ABRA LEAD-SILVER PROJECT

**HYDROLOGY AND SURFACE-
WATER ASSESSMENT**

**FURTHER INFORMATION REQUESTED - MINING PROPOSAL WITH MINE CLOSURE PLAN –
GALENA MINING LIMITED – G52/292, M52/776 and L52/194 – ABRA BASE METALS PROJECT –
REGISTRATION ID 76773**

Location of paste plant

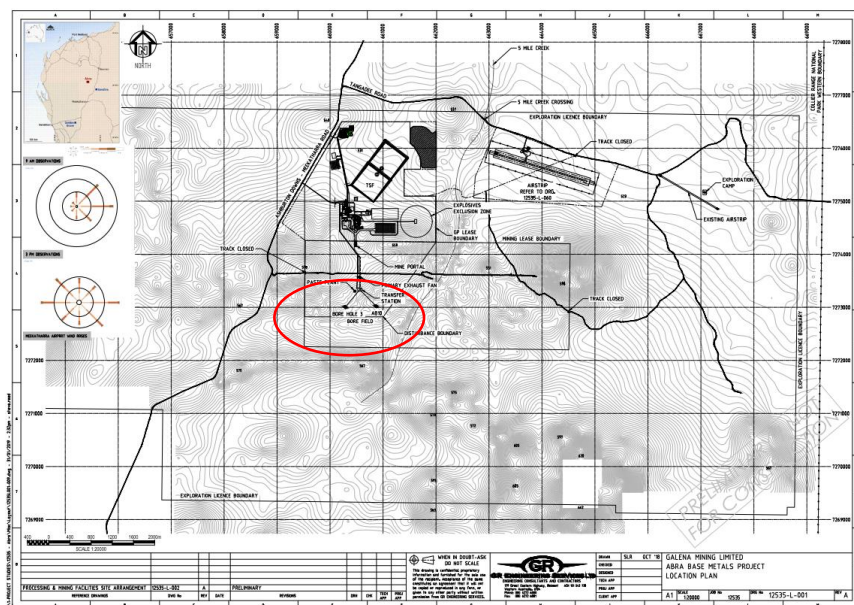
- i. It is noted that there will be a Paste Plant installed to support the Abra Project, however it is not clear if the disturbance for this has been included in Table 5. Furthermore, a Key Mine Activity table is not provided. Please confirm whether the Paste Plant is included as part of the 'Process Plant' disturbance footprint, otherwise please update this section to include the Paste Plant.

i The paste plant is not located within the main flotation process plant area. MP Rev 1 Figure 2 (reproduced below) shows the paste plant located above the orebody. Tailings will be pumped to the paste plant from the process plant. Surplus water from tailings dewatering will be pumped back to the process plant.

The area required for the paste plant is small. An area of 50m x 50m = 2,500m². This will be included in Table 6 (Rev2) - Key mine activity for m52/776.
